ADDRESS: 2530 S CLEVELAND ST

Proposal: Install aluminum clad windows at front and vinyl windows at side and rear

Review Requested: Final Approval

District Designation: Girard Estate Historic District, Contributing, 11/10/1999

(2) (G) & (H)

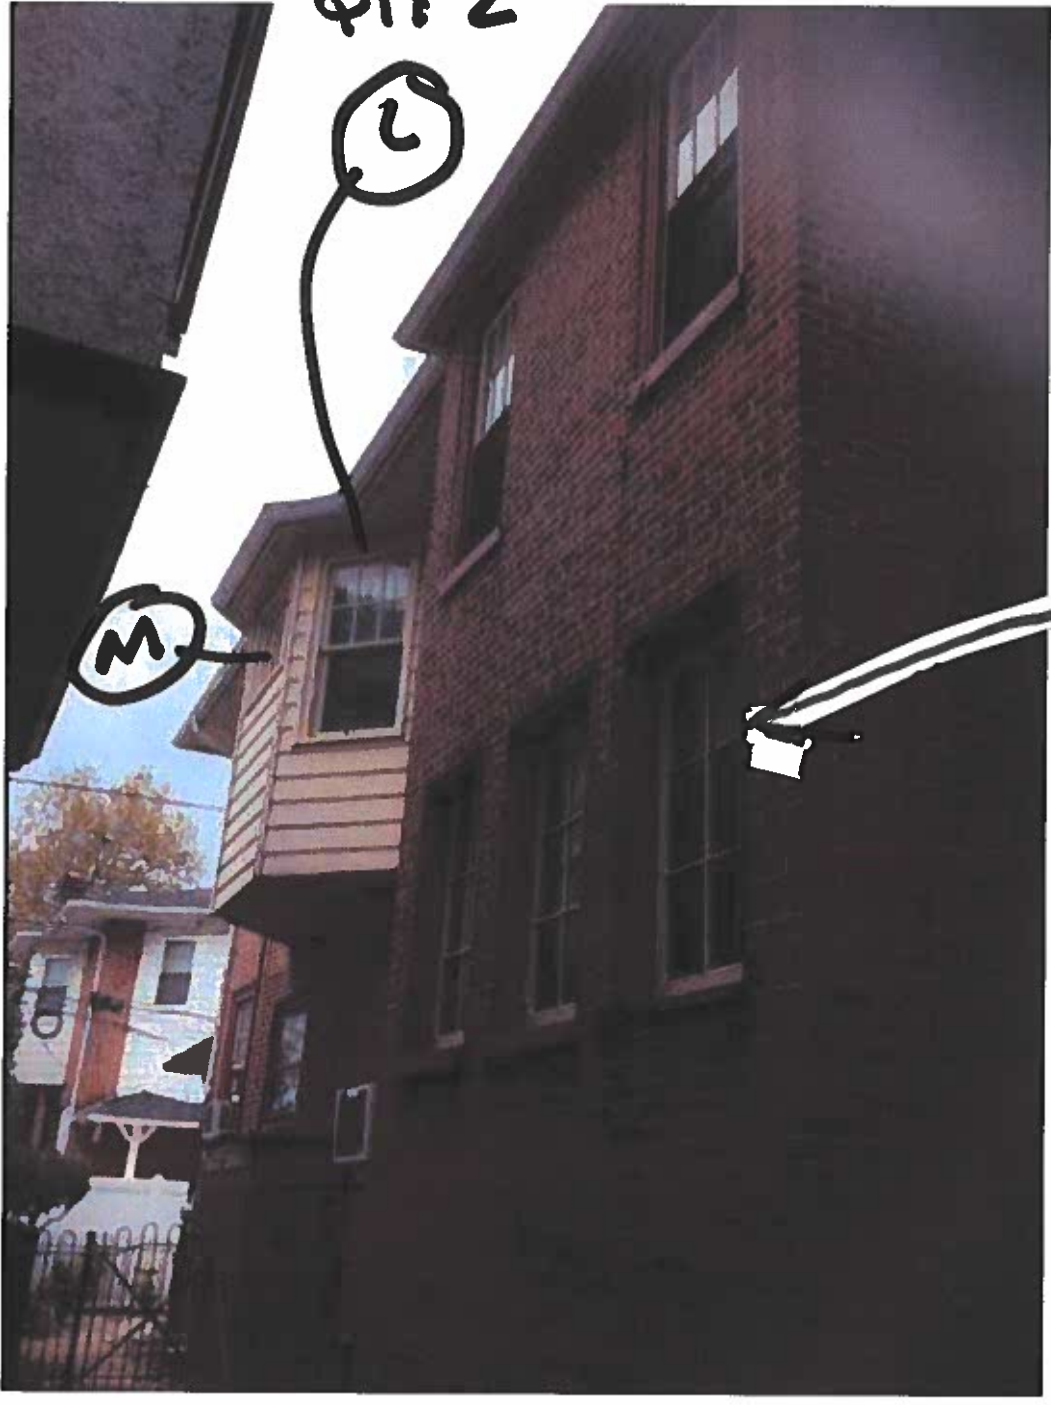
- The details presented in this application show a change in pane configuration for two prominent windows at the front façade, which should be changed to replicate the existing pane configuration.

- The windows proposed to replace the two French casement windows at the side of the house should match the configuration of the existing windows more accurately.

- the exterior glass of the replacement window is installed in the same plane as the existing windows;
- the pane configuration of the four narrow replacement double-hung windows accurately reflects the original 2/1 configuration;
- the replacements of the two French casement windows accurately reflect the original configuration; and,
- aluminum-clad windows are installed at the side and the rear where the current application proposed vinyl windows.

Harvey Industries, Inc.
Majesty Replacement
Wood Casement Window
(1/2 Scale)

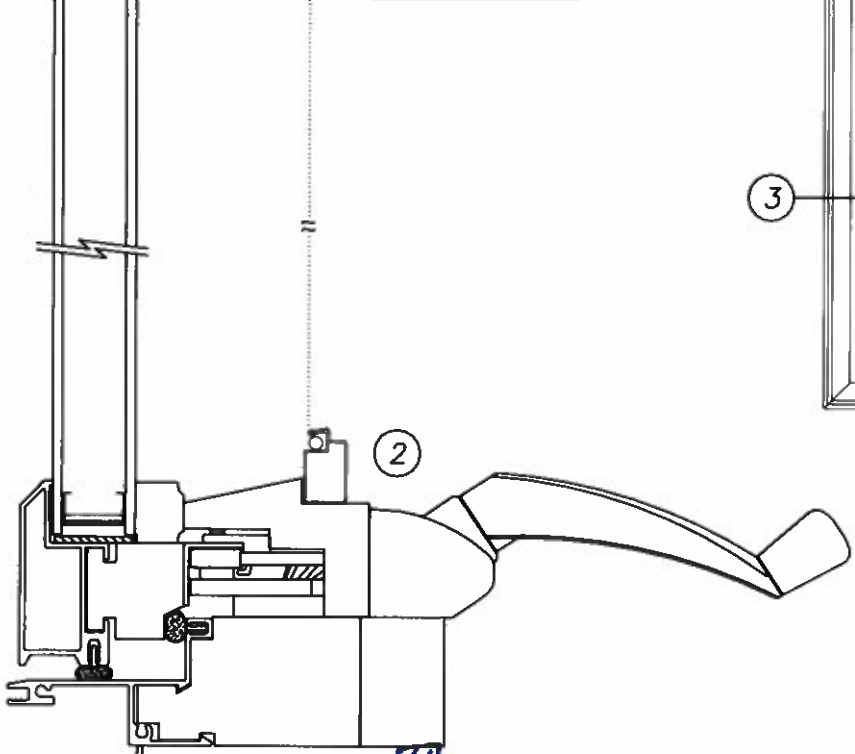
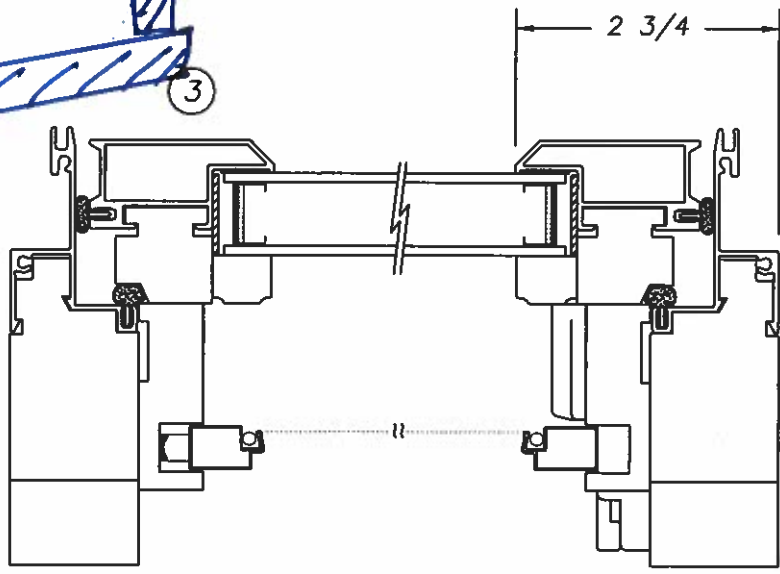
- The section drawings provided seem to indicate that the glass of the replacement windows would sit proud of the existing frames, which creates a non-historic condition. These section drawings should be revised to show that the exterior glass of the replacement windows will be installed in the same plane as the existing windows.
